From: [Eli Z Tsarovsky](#)
To: [Plan Commission Comments](#)
Subject: Plan Commission - 12.12.22 - Agenda Items 6-8
Date: Monday, December 12, 2022 9:27:37 AM
Attachments: [Lake Street Garage Committee Report \(1\).pdf](#)

My name is Eli Tsarovsky and I am the President of the Campus Area Neighborhood Association. I am emailing you all today in opposition to the current plans for the 415 N Lake Street Redevelopment in the 2nd Ald. Dist.

Lake Street Garage Steering Committee Report

Alternate Layout

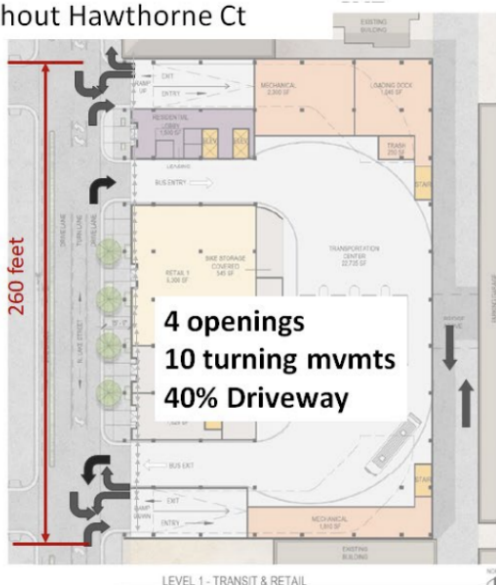
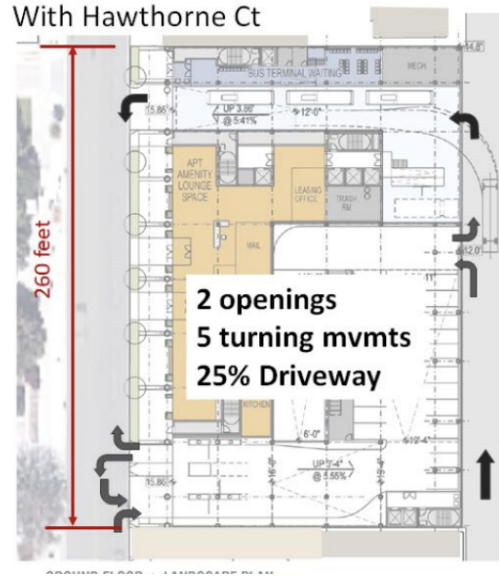
The traffic flow of the current proposal requires intercity buses to cross important, busy lanes of traffic that include **the Major BRT (Bus Rapid Transit) Lane, the unprotected Bike Lane, and the Major Sidewalk**. This is a major logistical flaw as this presents lots of opportunities for major backups on University Ave due to buses not being able to cross the lanes of traffic and a higher risk of accidents due to the Hawthorne Ct functioning as an alleyway and not being a controlled intersection. Not to mention University Ave is a much faster street than Lake Street and increases the risk of accidents like fender benders and bikers being hit during rush hour traffic. The development needs to use Lake Street for buses because it is a controlled intersection with a stoplight as compared to the Hawthorne Ct entrance which has no traffic signals. Additionally, the East Campus Mall BRT Spot can be inferred as a major bus stop for students commuting across campus. The three major residence halls are within a couple of blocks of this spot. Blockages at the Hawthorne Ct entrance will disrupt this major BRT system hub.

The three spots for buses seem inadequate and are shortchanging the intercity bus station potential. The bus terminal ought to have five bays like the old bus terminal and there needs to be a better plan for staging. They are trying to do too much at once and seem to be modeled after La Crosse without consideration of the unique challenges of this area. The Bus terminal is different and you can drive straight through it. This design

seems too complex at the moment. The proposal does not seem to completely address everything. The entrances for residential parking are on the same side as the Van Galder Bus entrance. This mix of traffic seems problematic with bus schedules and the residential experience. If there is a queue that wraps around the corner, this will affect the BRT lane and Metro Bus lane. There is also a need for more entrances and exits to accommodate queues during special events.

Without Hawthorne Ct

The alternative layout provided by the City of Madison Transportation Department
